42 HONEYSUCKLE DRIVE COTTAGE CREEK PRECINCT NEWCASTLE

NEWCASTLE CITY COUNCIL
DEVELOPMENT APPLICATION

ARCHITECTURAL DESIGN STATEMENT

SUMMARY OF PROPOSED AMENDMENTS

9.1 DESIGN CHANGES ROOF

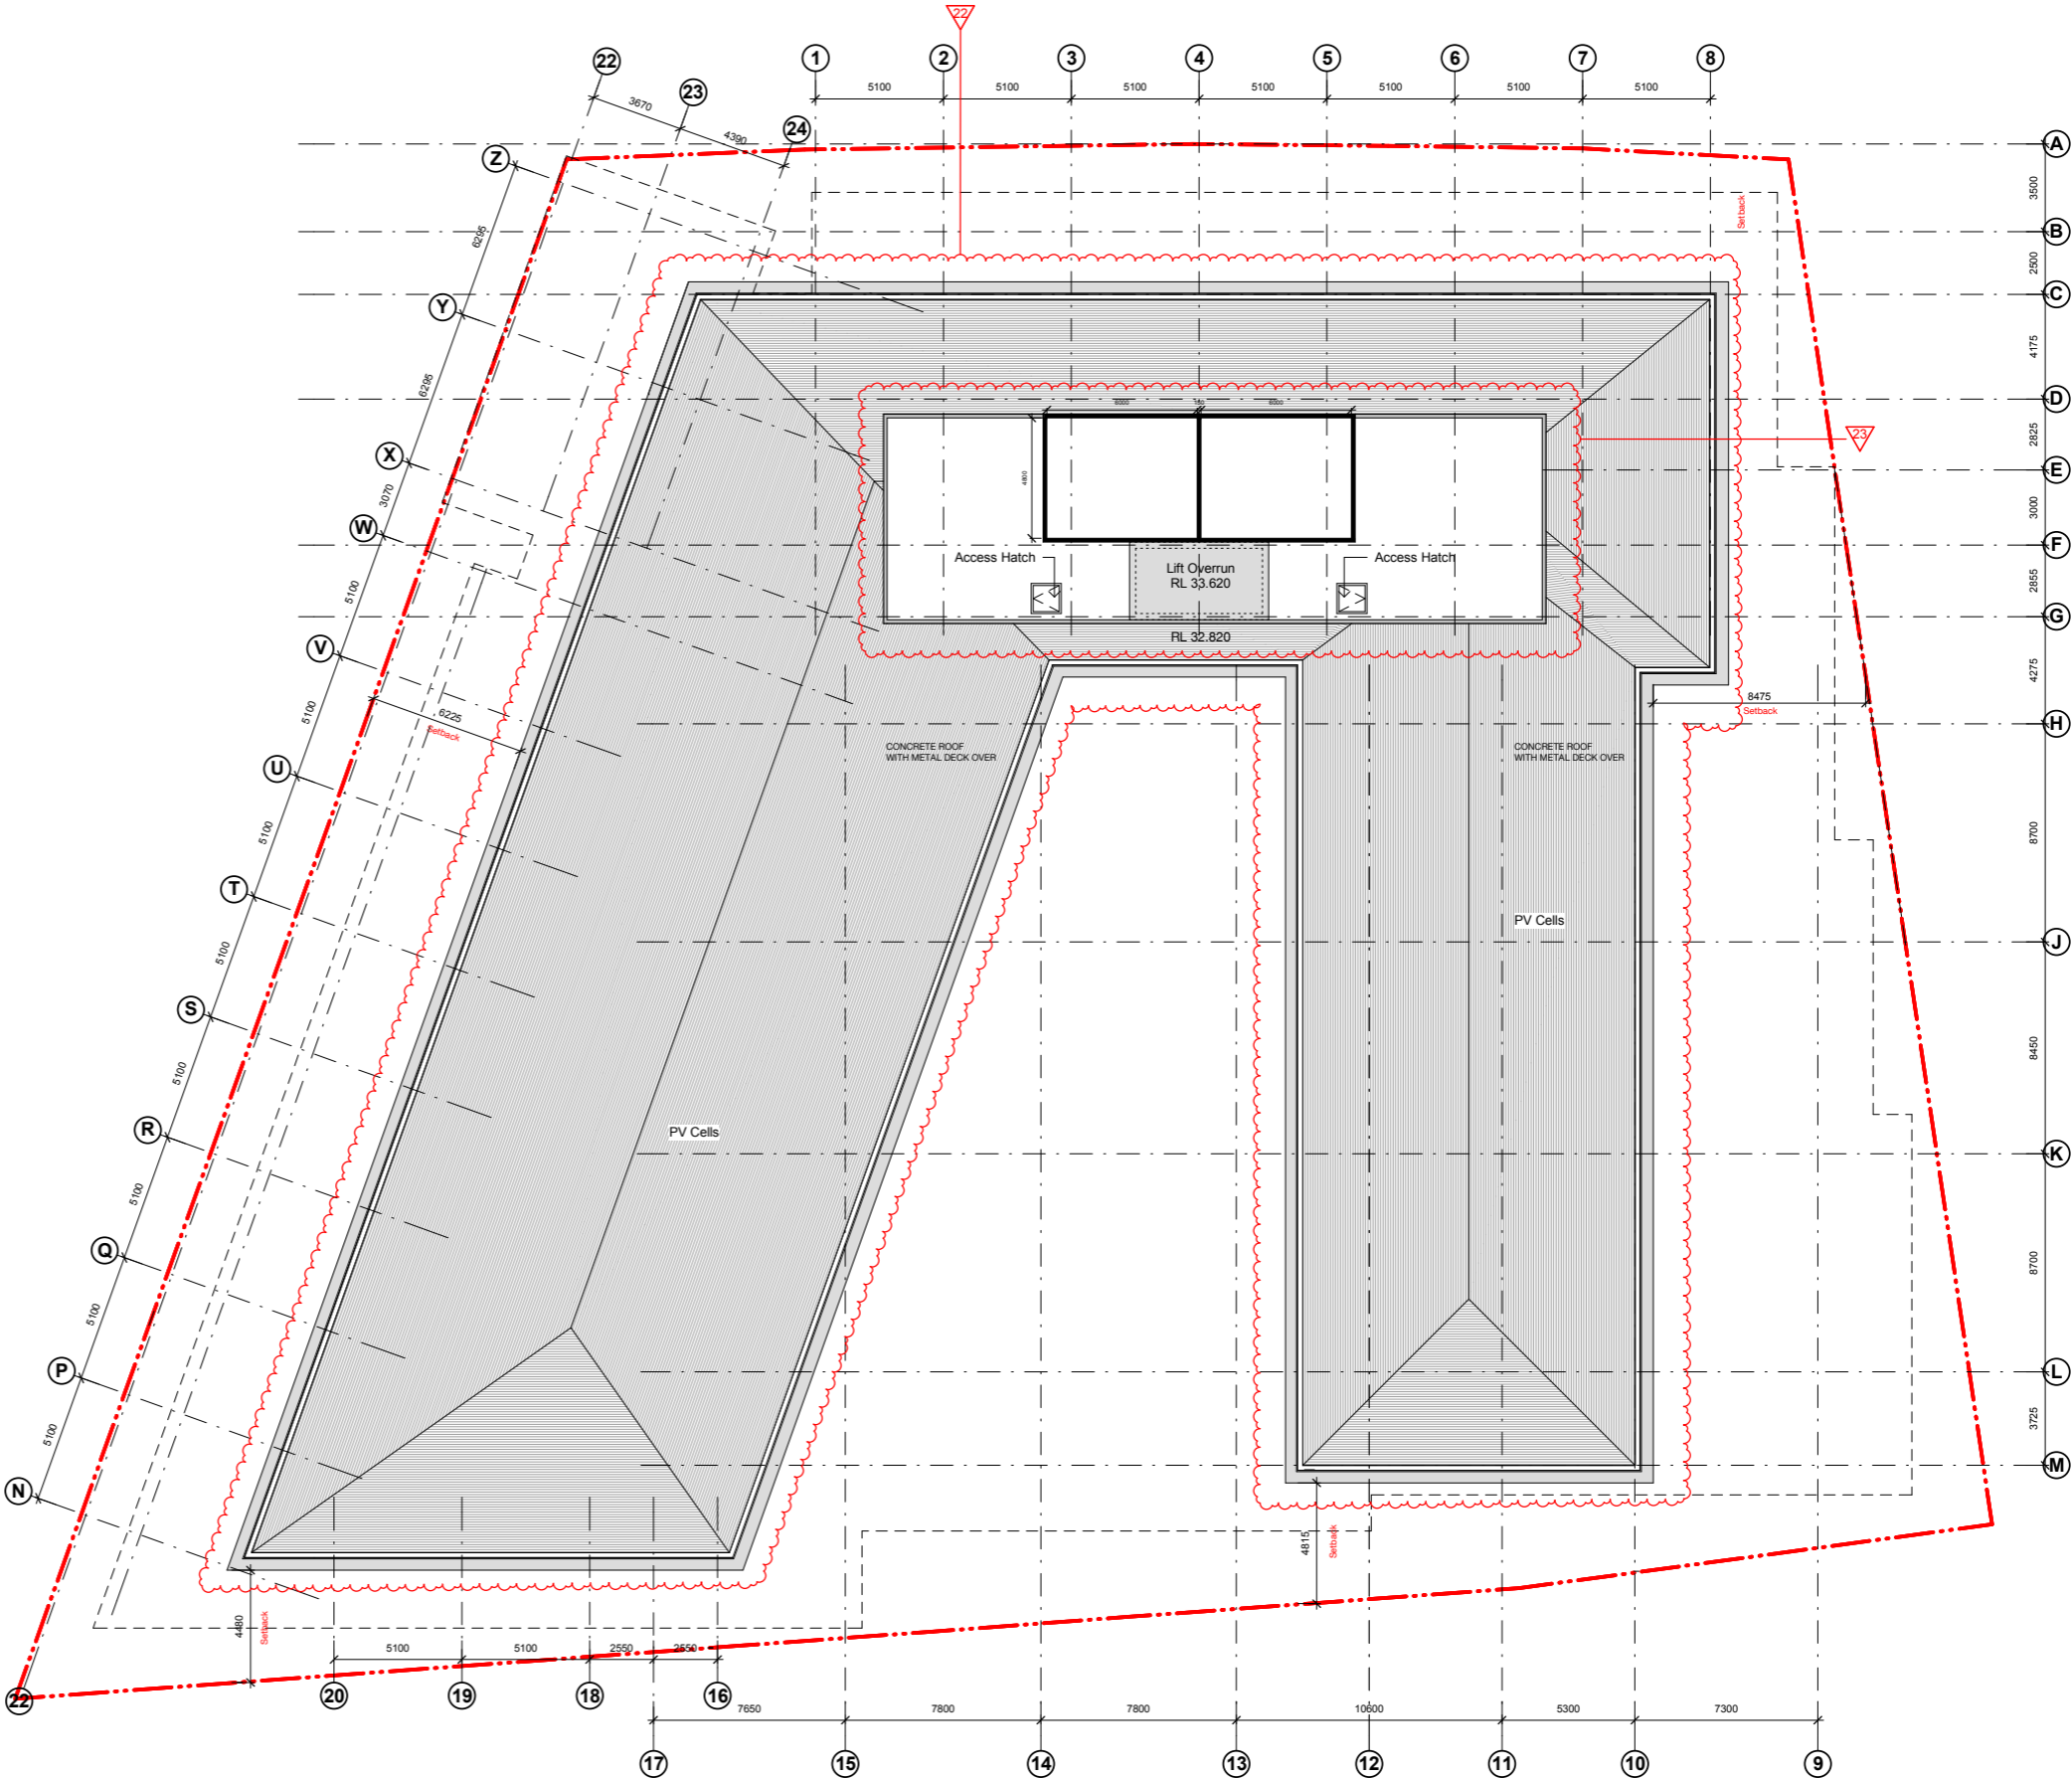
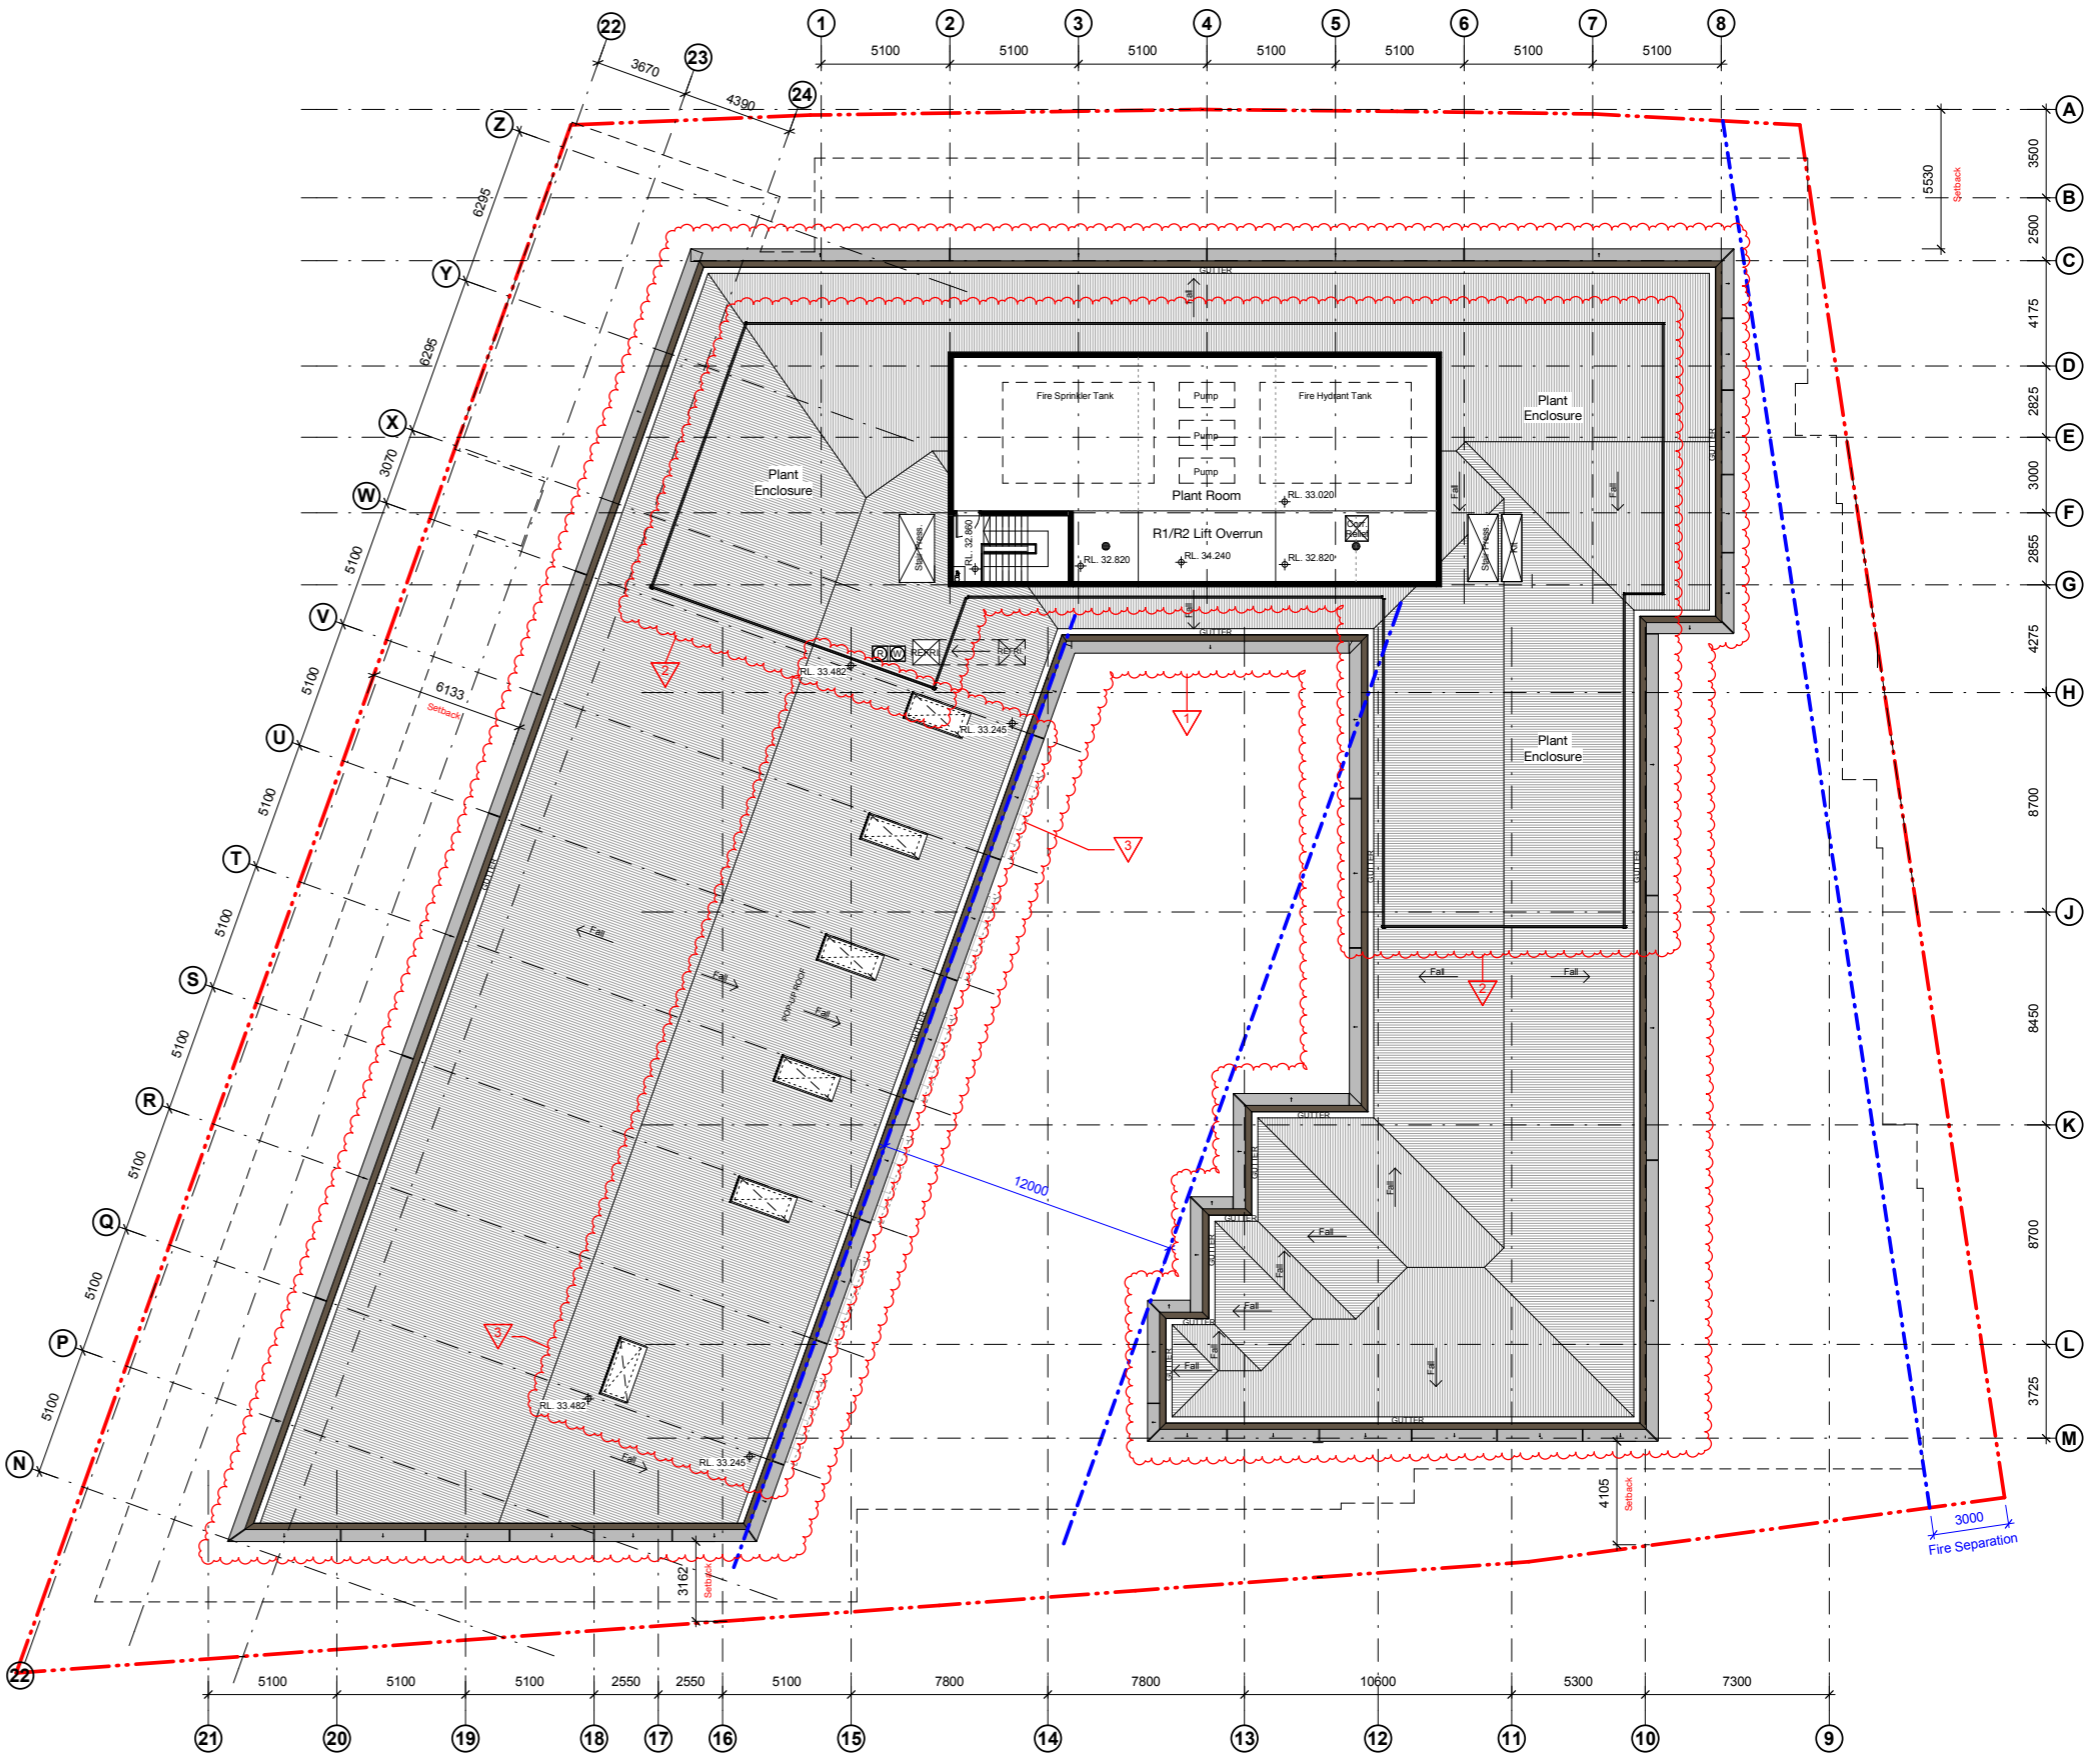
- 1 / Roof extent modified to match new envelope below
- 2 / Adjustments to the extents of rooftop plant enclosure
- 3 / Fixed skylights to 2-storey apartments facing into central courtyard
